DRUMSTA PROPERTY (1-05065)

PRELIMINARY PLAN:
 DRAKUSTA PROPERTY RE-SUBDIVISION
 10000 East Bayview Road, Suite 100
 Farmers Branch, TX 75448
 (972) 261-7888

Re: Drumsta property resubdivision, Plan # 1-05065,
postmarked 28 January 2005

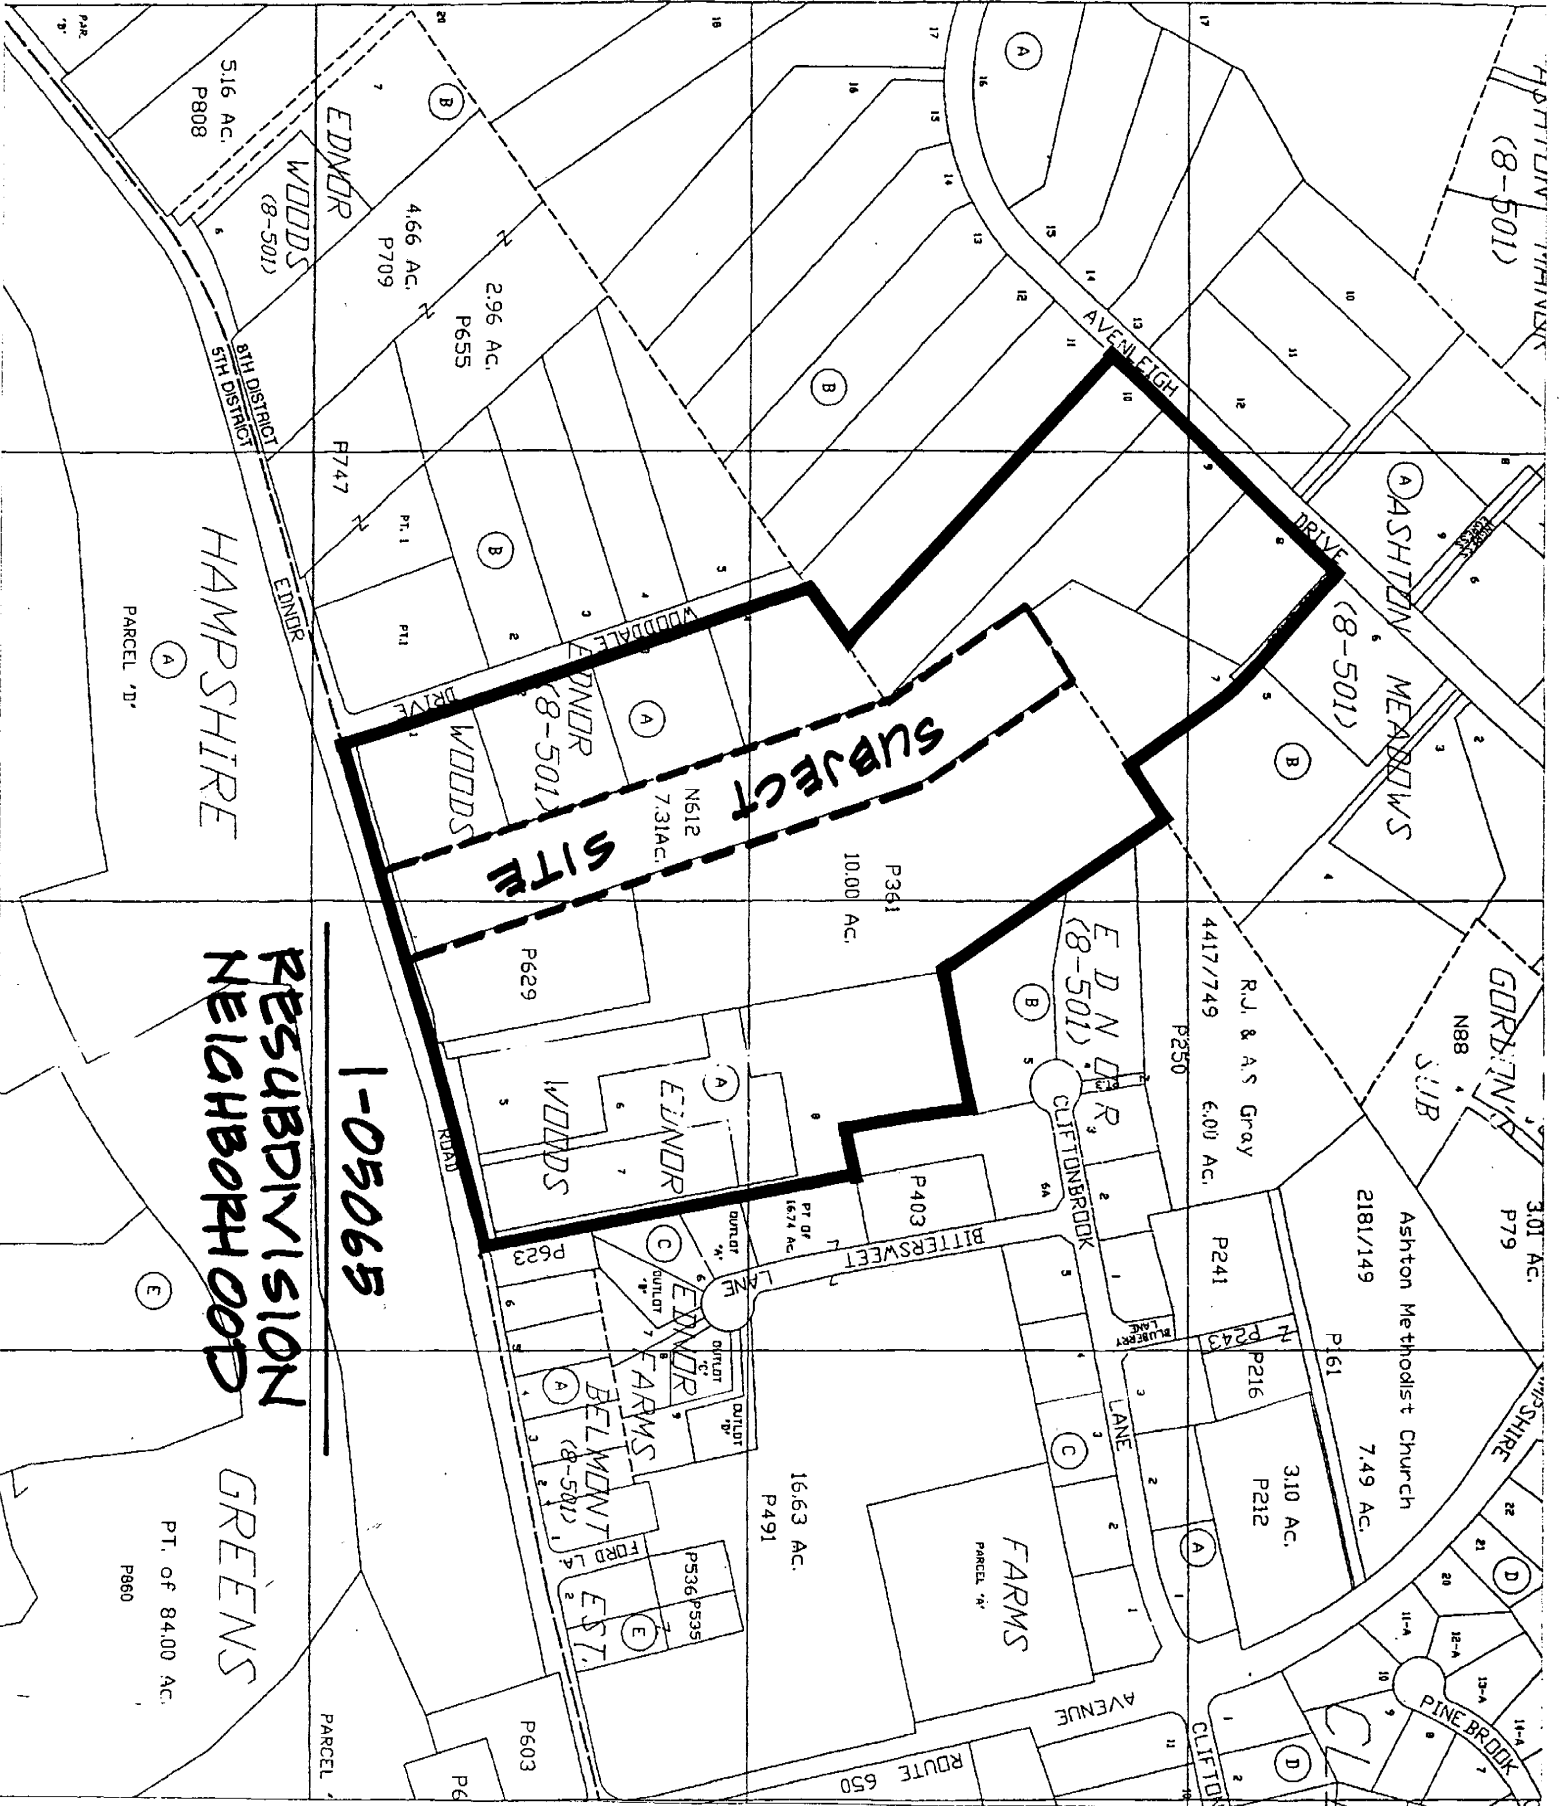
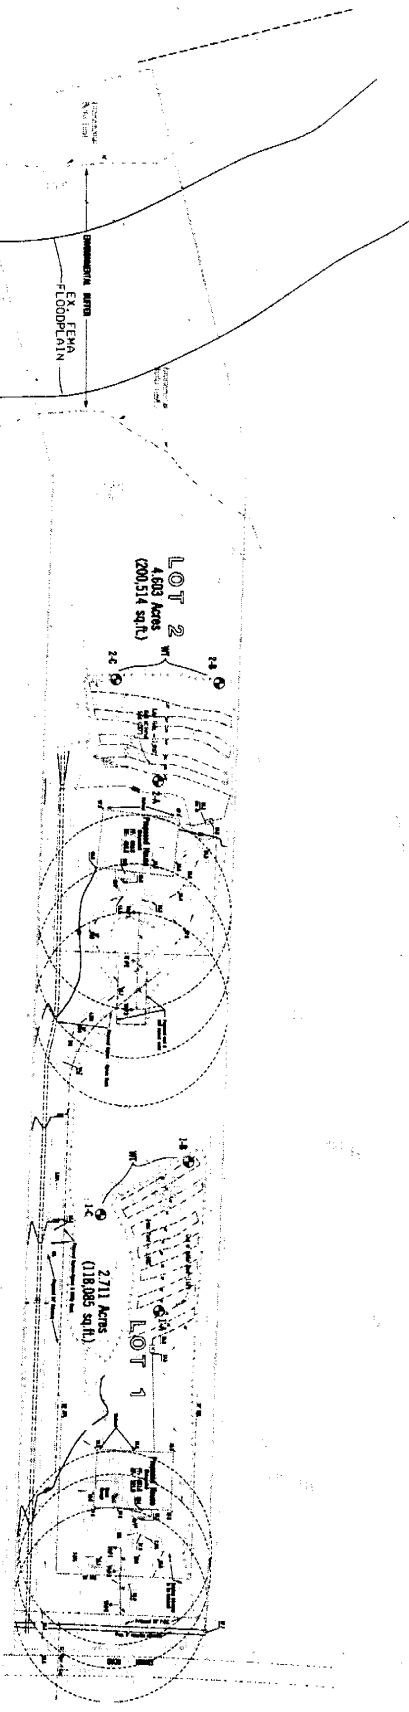
In contrast to the drawings provided, my well is actually located along the east property line, adjacent to the Drumsta property line. My crude measurements reveal it to be approximately 33 feet inside the east property line and 75 feet inside the south property line (see my mark on map – well marker plate on above ground pipe identifies the well as MO-73-1978).

Consequently, the septic tank, septic drainage field, proposed stormwater drainage path, and proposed driveway are all in close proximity to my well. Specifically, the septic tank for Lot 1 is aligned directly between the proposed Lot 1 house and my well; the proposed septic drainage field is within 100 feet of my well, and the proposed stormwater drainage and auto path are within 50 feet of my well. Unfortunately, my well is not only immediate to these, but downhill from them all.

The close proximity of the septic system creates the potential of significant contamination of my sole source of water. My well will be at significant risk of sewer contamination from the location of the proposed septic tank/drainage field. The proposed sewer drainage field is within 100 feet of my well and the septic tank is just outside the 100-foot radius. This is of great concern considering that nitrates in the water supply have been monitored closely in our area. In our well

specifically, just last year, a value of 9.4 was obtained (with a maximum contaminant level (MCL) of 10 considered elevated).

The close proximity of the proposed stormwater drainage and automobile pathway creates the potential of significant well contamination from: 1) salt contamination from the likely salting of the icy pavement during the winter months, 2) oil and gas contamination from the usual undercarriage leakage of autos passing along any roadway, and 3) the erosion and soil disturbance caused by initial grading, continued use on either gravel or asphalt, and perpetual surface water runoff.

The proposed driveway entrance follows the western most border of the Drumsta property line. Entrance to the property at the point is precisely at the point of a precipitous hill on Ednor Road.

Having the driveway entrance at the west end of the Drumsta property creates a significant and dangerous hazard to automobiles on Ednor Road. Specifically, an eastbound vehicle turning into the proposed driveway cannot see oncoming westbound traffic and the turning eastbound vehicle would not be visible to westbound traffic. Likewise, it would very difficult for an auto to see oncoming east bound traffic when turning east out of the driveway. At the driveway entrance, Ednor Road makes a precipitous drop, essentially hiding the east and westbound traffic from each other. It would only be a matter of time before an auto turning in or out of the driveway was broadsided.

The septic system of the Drumsta Lot 1 house must be directed away from my sole source of water (well #MO-73-1978). This would include redirecting the septic location and redirecting and/or shortening the drainage field to exist only on the east side of the property, not the west side where my well is located.

The wells belonging to Woodale Drive residents should undergo annual evaluation, specifically to include testing before land manipulation, and then surveillance testing to see if the manipulation is contaminating the water supply. The wells on Woodale Drive, especially mine being so close to the land manipulation, have the potential to become contaminated from many sources (septic system, salt/gas/oil from auto path, runoff erosion). Appropriate attention must be rendered to ensure a potable water source.

The new wells for both Lot 1 and 2 should be tested immediately upon drilling for potential contamination. My well has recorded borderline-high nitrate levels for years. The most likely source is from fertilizer utilized by the adjacent commercial nursery on the eastern edge of the Drumsta property (Dong Lee et ux, L4728 F221 P629). Being in such close proximity (proposed well locations for Lot 1 show them only a matter of feet from the eastern property border adjacent to the nursery), it is paramount to test them for herbicide, pesticide, and nitrate contamination. *Should the buyers of these houses have small children, they could be at significant risk of poisoning, to include methemoglobinemia from elevated levels of nitrates.*

Move the property driveway entrance to the eastern border of the property, adjacent to the commercial nursery. Having the entrance and access road on the western border of the Drumsta property creates a significant safety hazard on Ednor Road. This blind spot will be an accident just waiting to happen. Additionally, having the access road cross my well on the western property border (less than 50 feet from my well) creates the potential of significant contamination (road and soil runoff). I understand that creating the road on the eastern border may pose several issues: 1) the access road would be close to the eastern edge of the Lot 1 house (perhaps necessitate shifting the house a bit westward), 2) necessitate reconfiguring the garage entrance, 3) trees lining the eastern border (yet these are not a protected tree as I understand). Therefore, either removing the single row of trees (are these fast-growing Leland Cypress?) or making the access road just inside the trees would seem like a small sacrifice to ensure the safety of the new families, travelers on Ednor, and our water supply.
